REFERENCE:	Nova Bus Manuals
SECTION:	12: Interior Furnishing
RS N°:	MQR 7621-1007
EFFECTIVE IN PROD.:	N/A

SUBJECT:	Articulation stanchion
JUSTIFICATION:	New improved stanchion is now available for installation in the articulation section of the vehicle.

Figure 2 - Typical View of Articulation System Inside the Vehicle

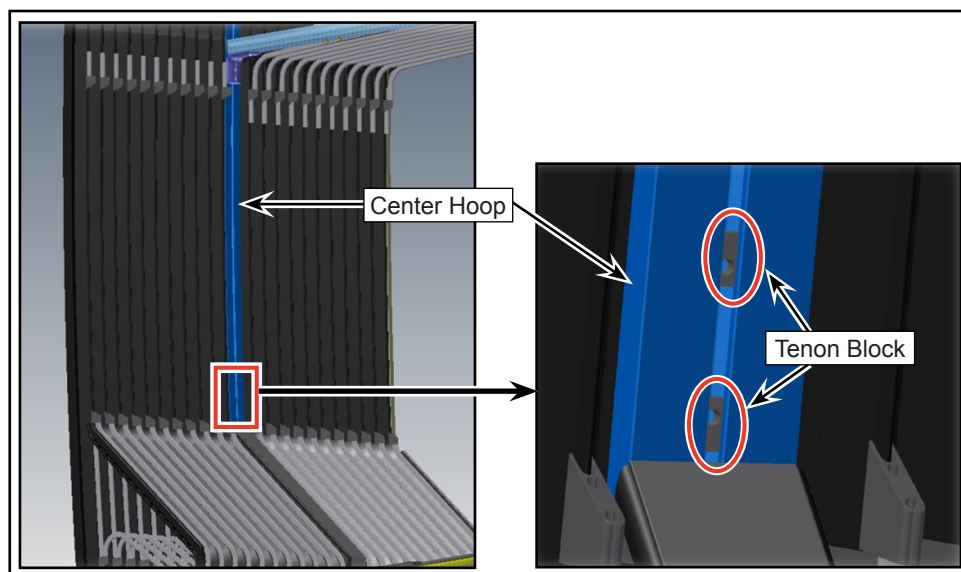
- 1.3. Locate the articulation area inside the vehicle (see Figure 2).

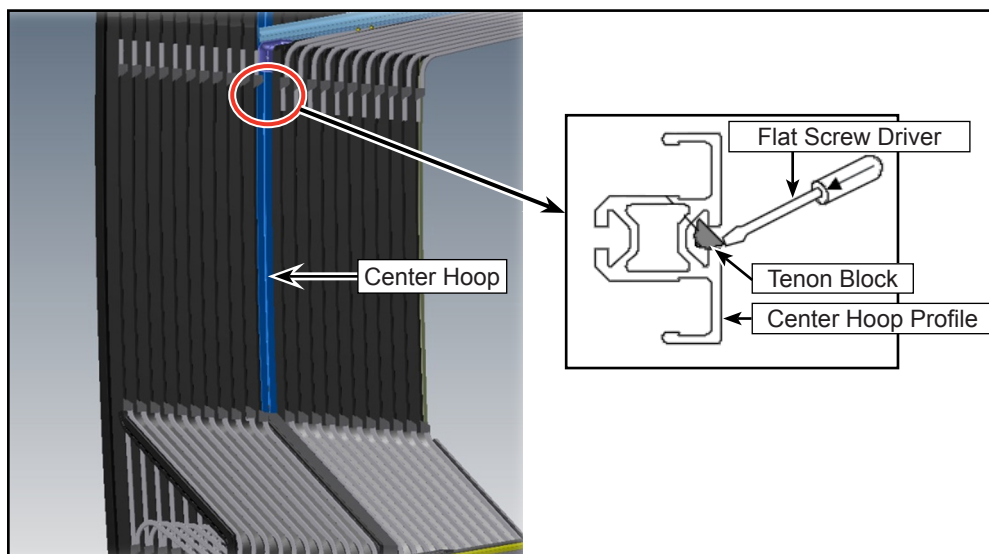
- 1.4. Remove the existing stanchion fixed to the center hoop of the articulation. Discard the stanchion, bolts and washers (see Figure 3).

- 1.5. Retain the tenon blocks at the same location (inside the center hoop aluminium profile) as shown (see Figure 4).

- 1.6. Install the new tenon block into the center hoop profile (right below the horizontal guiding profile) on both sides with a flat screw driver as shown (see Figure 5).

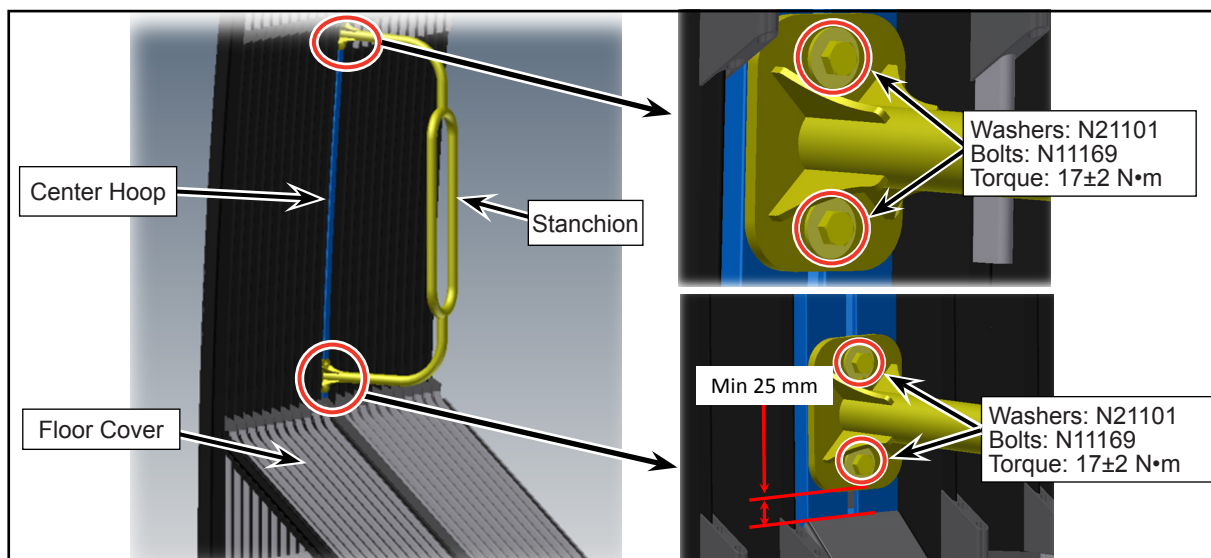
- 1.7. Install the new stanchion on to the tenon block present inside the center hoop profile with the hardware provided (see Figure 6).
- 1.8. Ensure that enough gap (Min. 25 mm) is left between the lower edge of the stanchion and the floor cover profile as shown (see Figure 6).
- 1.9. Apply blue thread locker and torque the bolts as specified (see Figure 6).

Figure 7 - Typical View of Stanchion Orientation

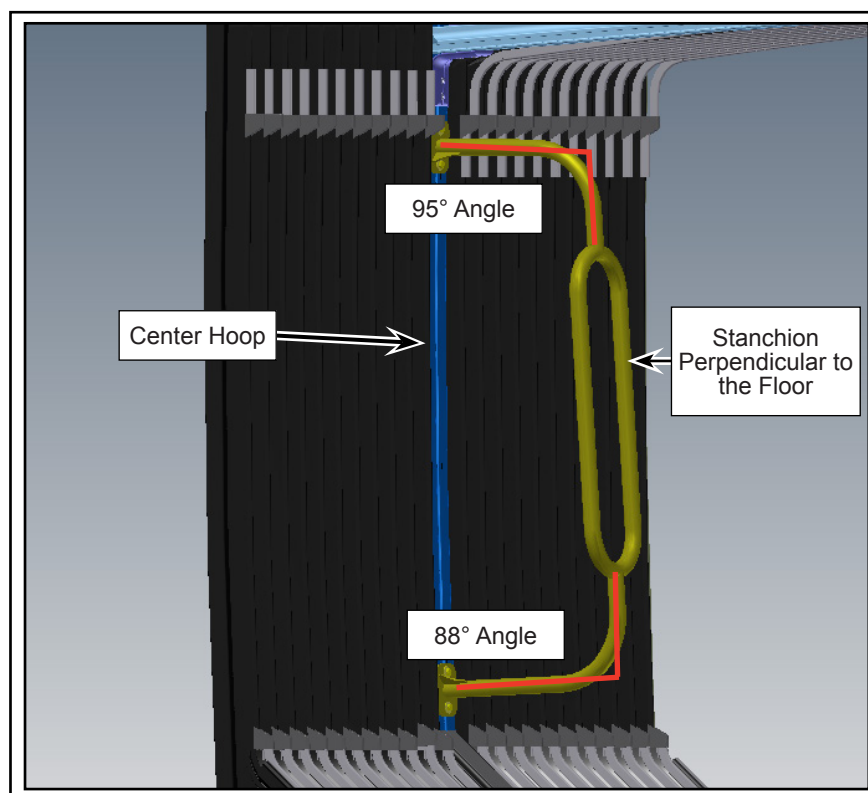
- 1.10. Ensure that the stanchion is vertical (perpendicular to the floor) (see Figure 7).
